# **ACER Decision on the ERAA 2021: Annex I**

**DECISION No 02/2022**  
**OF THE EUROPEAN UNION AGENCY**  
**FOR THE COOPERATION OF ENERGY REGULATORS**  
**on the European Resource Adequacy Assessment for 2021**  
**Technical annex**

**22 February 2022**

Figure 1: Charging profiles for electric passenger cars - assumptions from ENTSO-E and selected countries (percentage of daily charging)

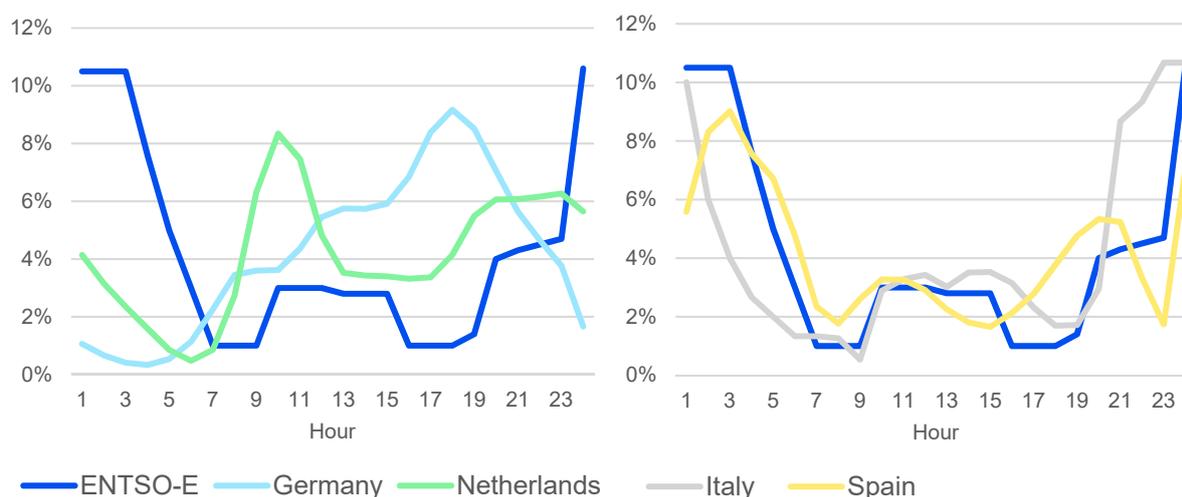
Figure 1 points to some similarities and differences across the different passenger electric vehicle charging profiles. For the majority of Member States, the bulk of charging is assumed to occur in the evening and night hours (possibly associated with home and off-street charging) and during office hours (possibly associated with workplace charging). In the vast majority of cases, some electric vehicle

Figure 2: DSR potentials per cost band and as a share of total DSR potential for EU-27 - 2025 assumptions

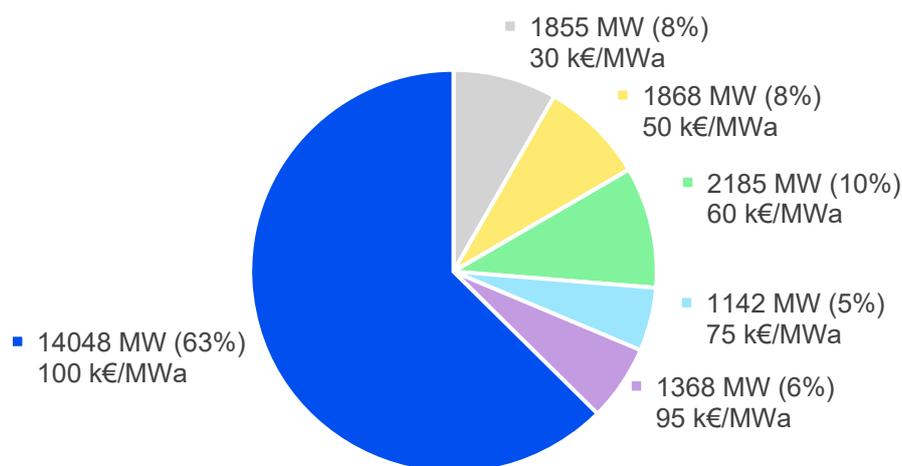
Figure 2 presents the additional DSR potential per cost band across the EU-27, in terms of capacity and as a share of the total DSR potential. The graphs show that the largest share of the additional DSR potential, around 63%, is allocated to the highest cost band. ACER understands that this band relates to DSR potential in the commercial sector. On the other hand, the potential for low-cost DSR (bands with annual costs of 30 and 50 k€/MWa) is limited to less than 4 GW, or 16% of the total DSR potential. Essentially, the ERAA 2021 implicitly assumes that the low-cost DSR potential is largely exploited through the exogenously determined assumptions. The assessment does not provide any evidence for it. Moreover, the total costs of the highest-cost DSR band are higher than the equivalent costs for Open-Cycle Gas Turbine (OCGT) power plants, making this DSR potential uneconomic in any event.<sup>24</sup> In other words, the model would never invest in this DSR potential, as OCGT power plants would always be more economic in the model.

Figure 4: Differences in installed generation capacity between Summer Outlook 2021 and National Estimate scenario – 2021 and 2025 assumptions, respectively (GW)

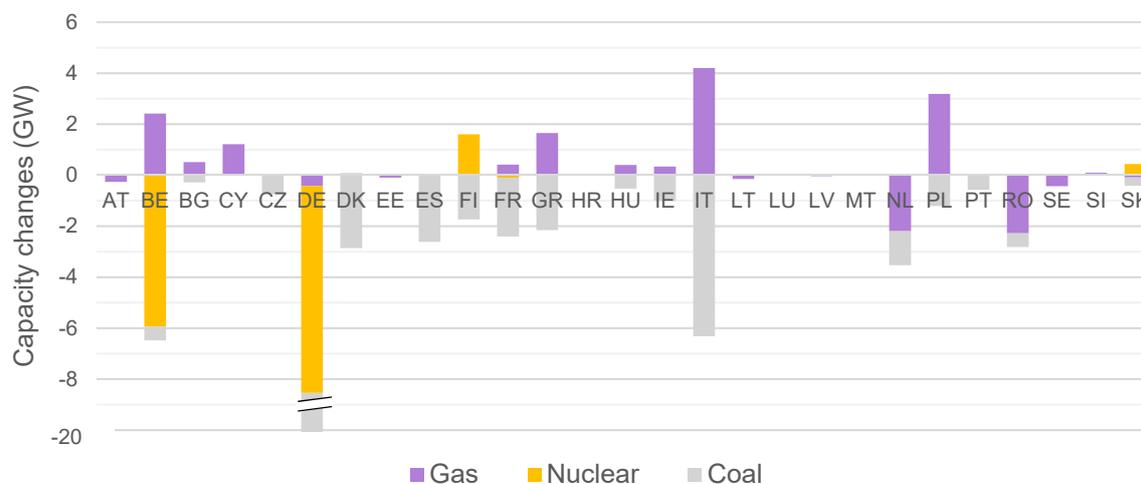
In addition, ACER has analysed the differences in thermal capacity between today and the ERAA 2021 assumptions for 2025. To perform this comparison, ACER has used the assumed installed capacity in the Summer Outlook 2021 as the most reliable source of currently installed capacity.<sup>41</sup> We compare these installed capacities with the assumptions under the National Estimates scenario drawn by the TSOs, as this largely reflects any known phase-out decisions and development of new plants.<sup>42</sup> The analysis shows that around 67.5 GW of thermal capacity are expected to shut down between today and 2025, while around 16.5 GW are added in the same period.<sup>43</sup> Figure 4 presents the changes in installed capacity between today and the 2025 assumptions of the National Estimates scenarios for natural gas, nuclear, coal and lignite generation. The total amount of closures and additions for these technologies amount to 56.4 GW and 16.5 GW, respectively.<sup>44</sup>

Figure 5: Assumed forced outage rates for gas technologies across EU-27 bidding zones - 2025 (percentage)

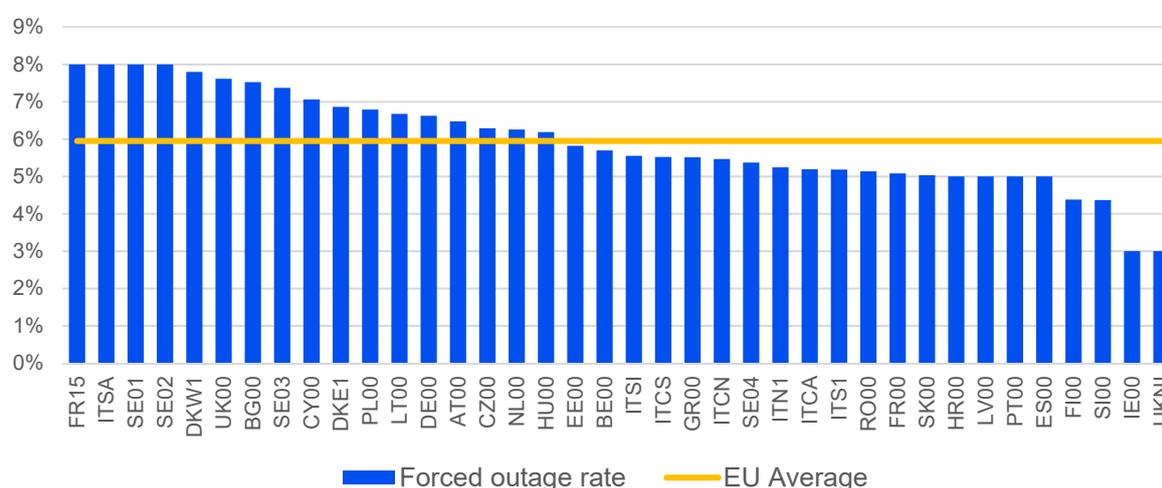
Figure 5 presents the weighted unplanned outage rate for gas generation, for each bidding zone in EU-27 and the average across the whole of EU-27 (orange line). Gas generation will form the bulk of thermal generation in the future, as several Member States gradually phase-out other thermal generation, such as more polluting coal-fired and lignite-fired power plants, or thermal capacities retire due to unfavourable economics. The figure shows that forced outage rates vary across EU-27 from 3% - 8%, with an average of around 6% across the region. While this range might appear narrow at face value, a 1% improvement in the forced outage rate is equivalent to an additional 2 GW of gas capacity on average across the peak hours. This means that a small change in the unplanned outage rate for gas generation has an appreciable impact on its available, average capacity and may subsequently affect the results of the assessment.

In relation to unplanned outages, ACER recommends that ENTSO-E investigates the impact of pricing signals and tighter markets on forced outage rates for gas technologies in particular (low priority). As explained above, gas-fired generation will represent the main form of thermal generation in the future. As the market disposes of current over-capacity and simultaneously market reforms progress to improve the functioning of the wholesale market (e.g. via the market reform plans developed by Member States pursuant to Article 20 of the Electricity Regulation), it is expected that the market signals for gas-fired power plants will improve. At the same time, current unplanned outage rates for these plants are

Figure 6: Assumed installed battery storage capacity in the EU-27 – 2025 (GW)

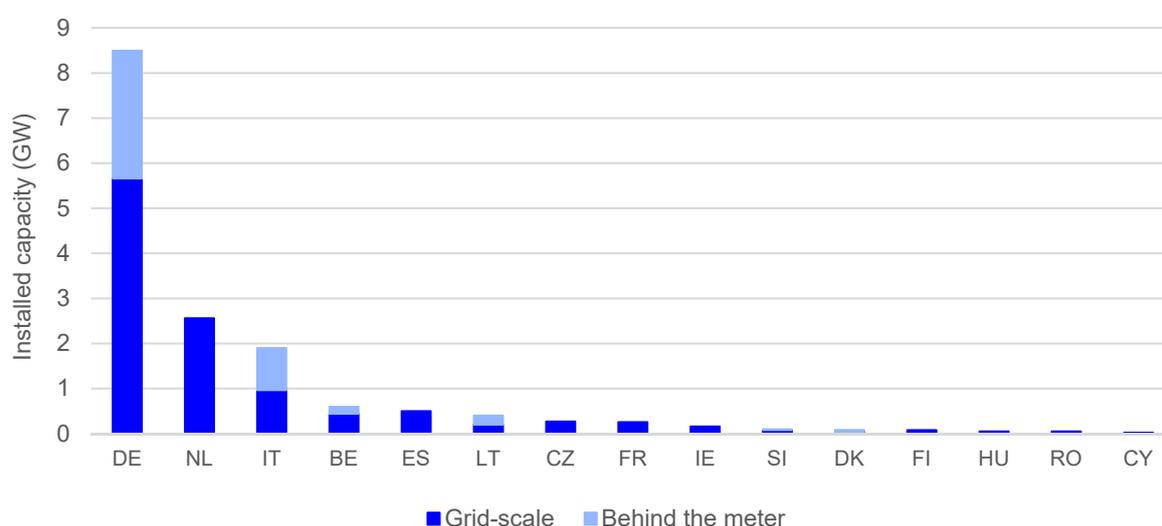
Figure 6 presents the assumed installed battery storage capacity per bidding zone in 2025. ACER observes that battery storage features in just over half of the Member States in EU-27, and for many of these Member States the assumed capacity is negligible. It is unclear from the Report what drives these significant differences across Member States (e.g. regulatory framework, support policies).

Figure 7: Average NTCs per border - 2020 (realised) and 2025 (ERAA 2021 assumptions) (MW)

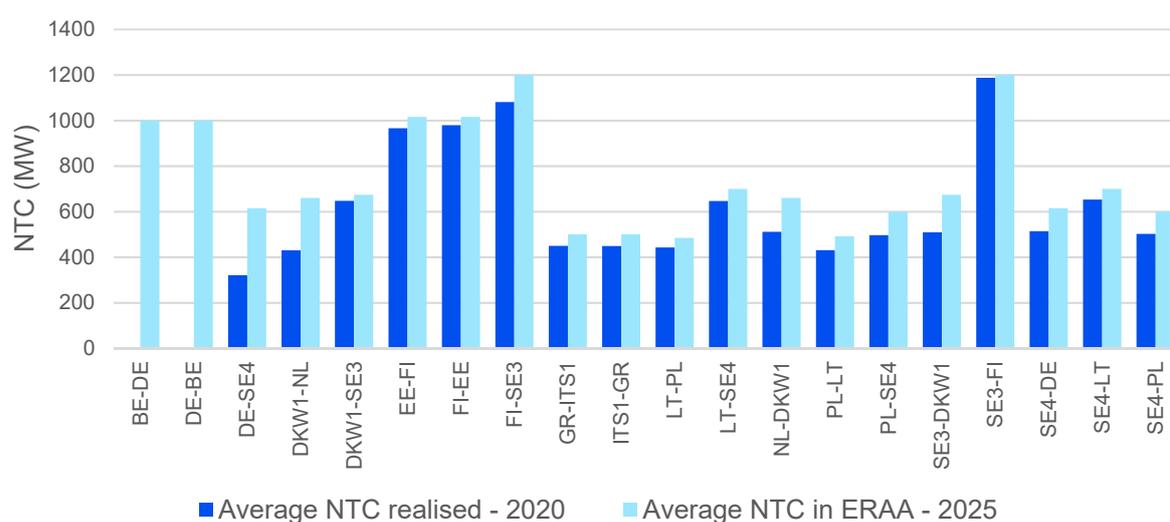
Figure 7 presents the average NTC value in 2020, and the average NTCs assumed for 2025 in the ERAA 2021, for each DC border.

Figure 8: ACER’s assessment of the 70% minimum target based on the ERAA 2021 NTC assumptions for 2025

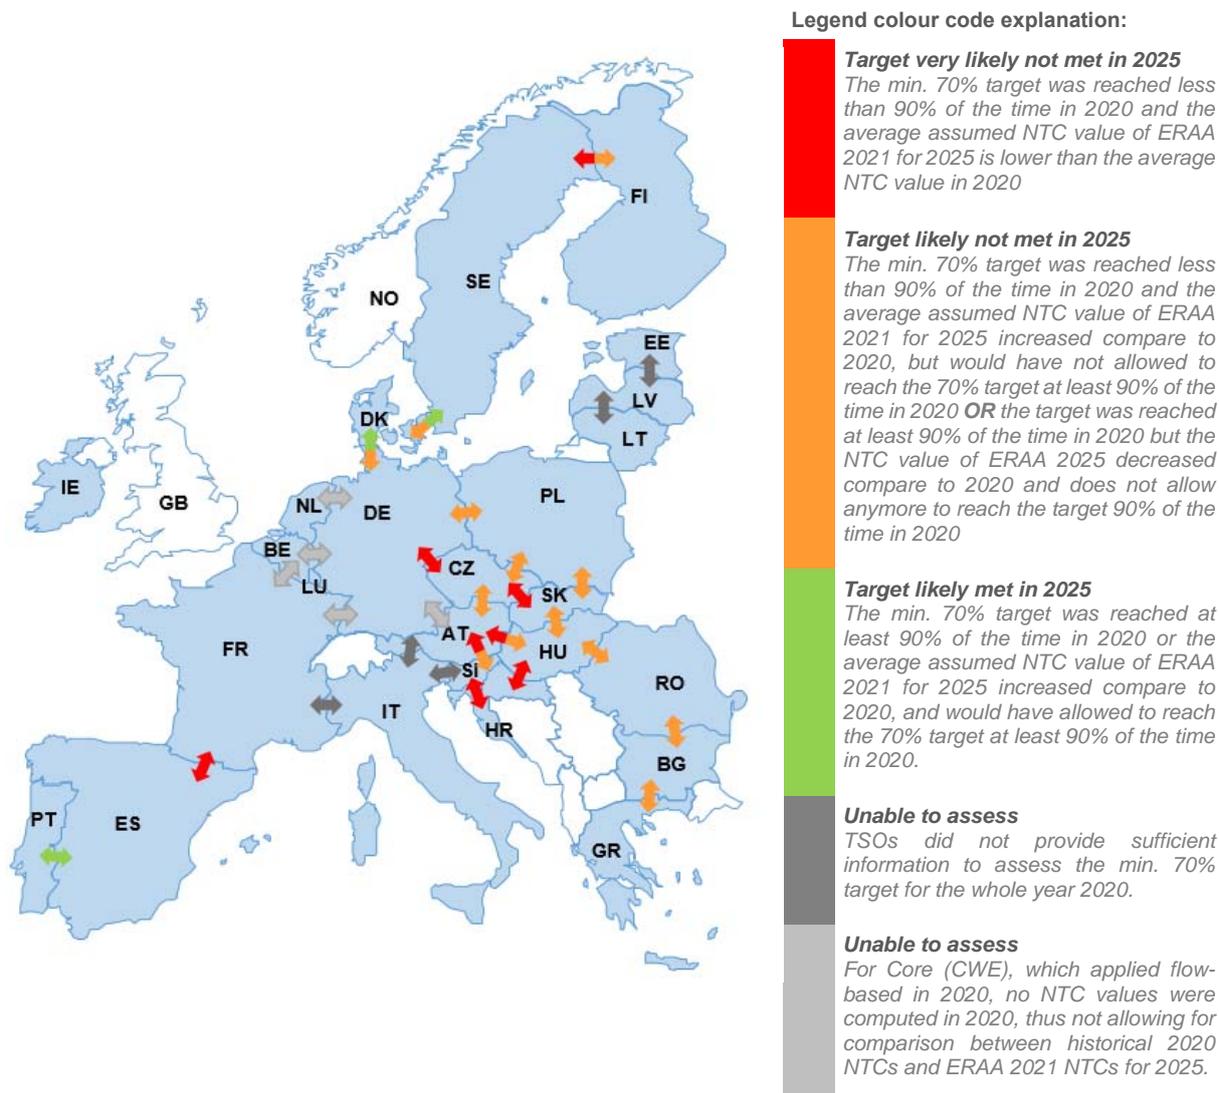
Figure 8 shows whether NTCs for 2025 of the ERAA could allow TSOs to meet the 70% minimum target for each AC border.

Figure 9: Differences in FCR requirements per Member State – 2020-2025 (MW)

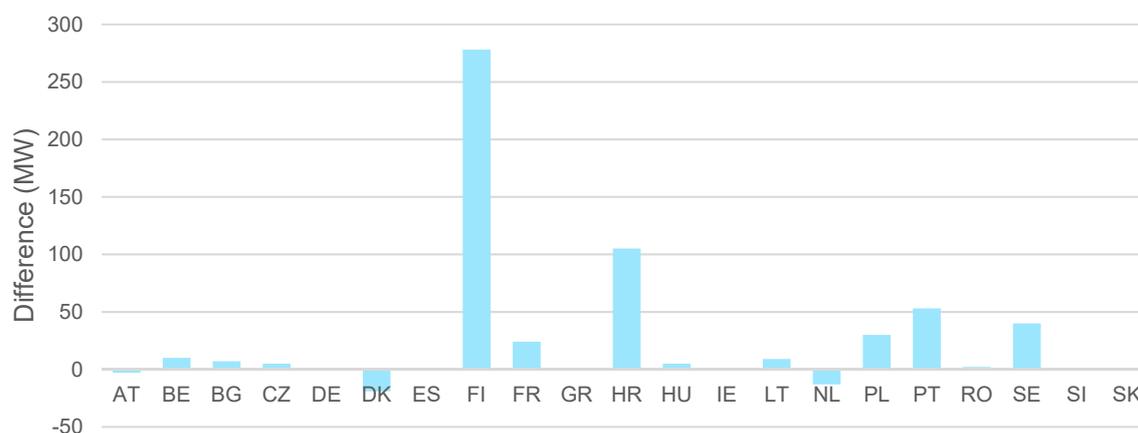
ACER has compared the ERAA 2021 assumptions for FCR and FRR requirements in 2025, with the actual 2020 requirements based on the volumes collected for ACER-CEER’s Marker Monitoring Report 2020 (ACER-CEER’s MMR 2020). Figure 9 presents the differences for the FCR requirements. The total requirement for FCR across the EU-27 increases to 4.6 GW compared to 3 GW currently. The graph shows that the requirements either increase or remain constant, while in limited cases the level of FCR reserves decreases slightly. In a couple of cases, FCR requirements increase significantly compared to current practices, notably for Finland (nearly 300 MW) and Croatia (just over 100 MW).

Future ERAAs would significantly benefit from clear explanation about the methodology used to determine reserve requirements and the main drivers for any changes compared to present (high priority).

Figure 10: Differences in assumed FCR requirements per Member State – 2020-2025 (MW)

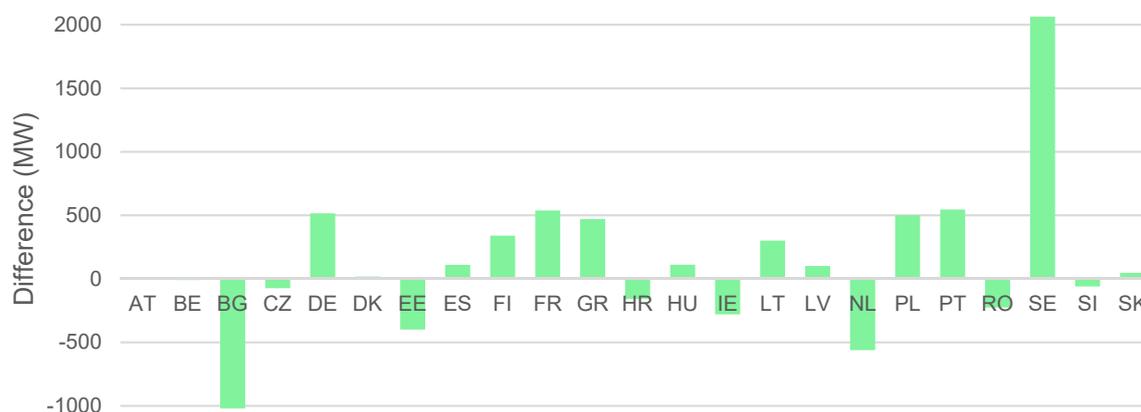
Similarly, Figure 10 presents the differences for the FRR requirements between the 2025 assumptions in the ERAA 2021 and the actual 2020 requirements, based on data collected for ACER-CEER’s MMR 2020. The picture is more mixed in this case. For the majority of bidding zones, the reserve requirement

increases. In several occasions, this increase is significant in absolute terms: around 500 MW for Germany, France, Greece, Poland and Portugal. For other bidding zones the increase is less pronounced (e.g. an increase of around 340 MW in Finland) or negligible. For a different group of bidding zones, the reserve requirement decreases compared to 2020. The reduction is more significant for Bulgaria (around 1000 MW) and the Netherlands (around 500 MW). Overall, the reserve requirement for FRR is projected to increase up to 28.2 GW in EU-27.

Figure 11. Comparison of the LOLE results between the economic dispatch (ERAA 2021 results) and the EVA model (central reference scenario without CM) – 2025 (hours per year)

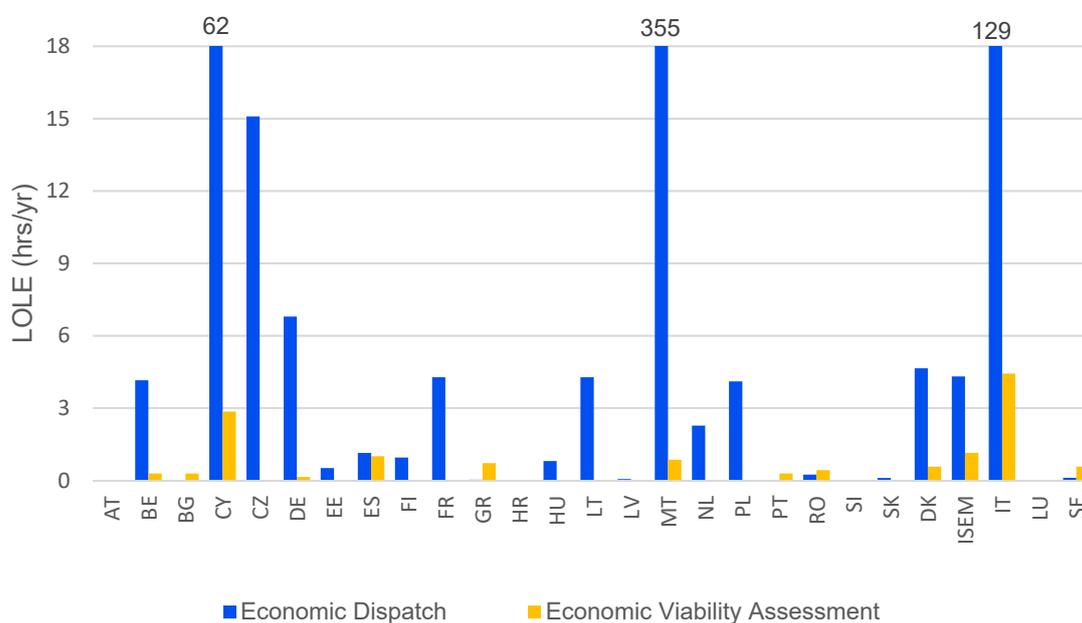
Article 6(6) and Article 6(9) of the ERAA methodology require that the EVA relies on the results of the economic dispatch to assess economic decisions. In this way consistency between the two models is ensured. A comparison between the loss of load expectation (LOLE) indicator from the EVA and economic dispatch, for the central reference scenario without CM, reveals significant differences between the two models (Figure 11). The expected energy not served (EENS) values of the EVA are zero or close to zero for almost all modelled zones, compared to the ERAA results that show non-zero EENS values in most modelled zones.<sup>63</sup> Hence, the ERAA 2021 does not provide an appropriate level of consistency between the EVA and economic dispatch, undermining the robustness of the approach followed and leading to dubious results.

As the EVA essentially determines the capacity resource mix that is available for serving demand, the implications of such an inconsistency are significant. ENTSO-E conducted a qualitative viability assessment of coal, gas, lignite and oil fired generation units based on the outcome of the economic dispatch model for the central reference scenario without CM.<sup>64</sup> The results indicate that in most cases resources are highly profitable, while in limited cases capacity is not profitable.<sup>65</sup> As an example, the examination of profitability of gas fired units, presented in Figure 12, shows that profits are several times higher than e.g. the fixed costs of existing gas units used in the model.<sup>66</sup> These profits are generally higher in modelled zones with high LOLE,<sup>67</sup> indicating that additional capacity can potentially reduce the adequacy risks without jeopardizing the viability of the existing units. Evidently, the EVA does not accurately capture the risks and opportunities of the economic dispatch market simulations. The results demonstrate an overall underestimation of the capacity resources that could have entered or remained in the market and thus an overestimation of the adequacy indicators.

Figure 12. Profitability of gas fired units based on expected revenues and costs from the economic dispatch results for the central reference scenario without CM – 2025 (€/kW)

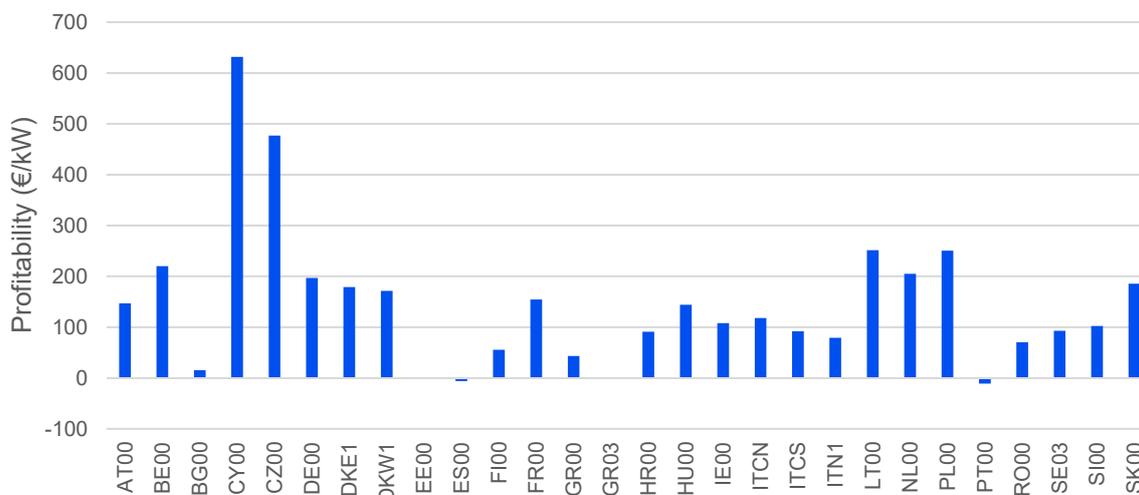
<sup>67</sup> As a characteristic example for Czech Republic profits of gas fired units reach 477 euros/kW, while at the same time LOLE is 15 hrs/year, and the EVA resulted in the economic decommissioning of 5GW of thermal units.

Figure 13: Assumptions for meeting the balancing reserves requirement per bidding zone in 2025

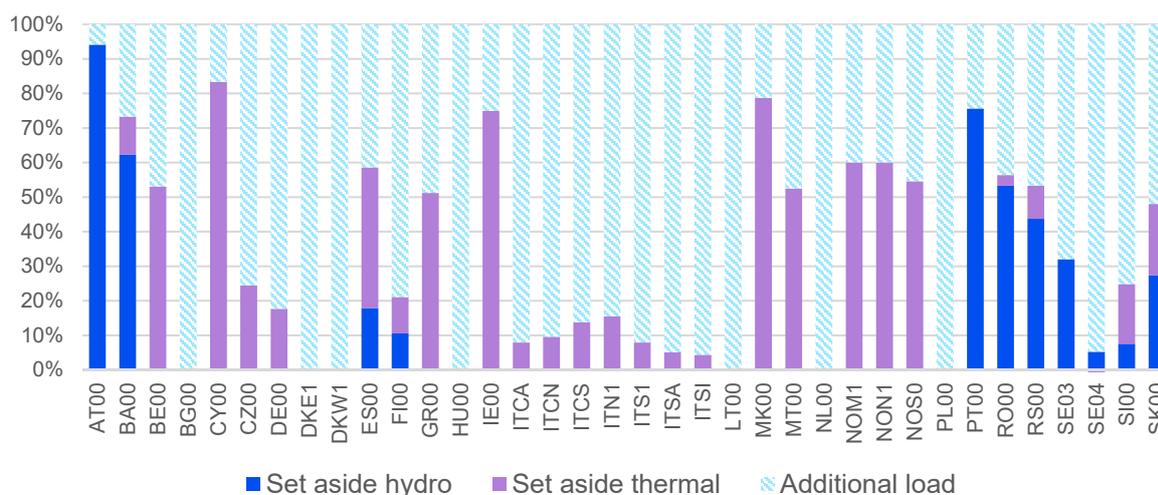
Figure 13 presents how Member States are assumed to meet their reserve requirement across the three types of resources in 2025. It shows that a few Member States are projected to meet their needs through primarily hydro capacity, while in most, the needs are met through a combination of different resource types. In several Member States, the reserve requirement is added as additional load, in full or partially.

- On the one hand, it can affect market prices in the economic dispatch modelling. In general, this simplification is expected to drive prices up. By adding load, the optimization algorithm will possibly clear at a higher value than if the reserve requirement was treated outside the energy market. Particularly, this would be the case if the resources serving as balancing reserves were high in the merit order, i.e. have a high short-run marginal cost. ACER expects this approach to affect prices depending on the relative size of the added load in relation to the demand levels; the higher the relative size of the added load, the greater the potential impact on prices. Figure 14 shows the added load, due to the reserve requirement, as a share of the average peak and off-peak demand across all climate years. The added load is particularly prominent in smaller bidding zones, compared to larger ones.

- On the other hand, this simplification conceals revenues that resources reserved by the system operator for balancing purposes would earn through capacity payments. Resources providing ancillary reserves, particularly FCR and FRR, would normally receive an availability payment (in €/MW for being available to the system operator) and a utilization payment (in €/MWh, reflecting their short-run marginal cost). The ERAA 2021 essentially omits entirely the availability payments these resources would receive, thus undermining their profitability in the assessment.

- The addition of balancing reserves requirements as load can have a further negative impact on resources with limited energy capabilities, such as storage. The additional load requires an equivalent amount of energy for supply to meet demand. If this additional production is met by resources with limited energy capabilities, it could deplete their available energy, and thus undermine their contribution to resource adequacy. In reality this capacity resource would not produce such an amount of energy but rather be set aside, to deal with any sudden and short-lived disturbances in the system.

While the current approach is in line with the ERAA methodology, ACER believes it unnecessarily distorts the results of the assessment. Therefore, ACER recommends that future assessments treat balancing reserves outside the economic dispatch, or in other words the assessment allocates the reserve requirement to specific capacities and does not treat it as added load (high priority). Such an approach would effectively imply that such resources would make sufficient revenues to be economically viable.<sup>95</sup>
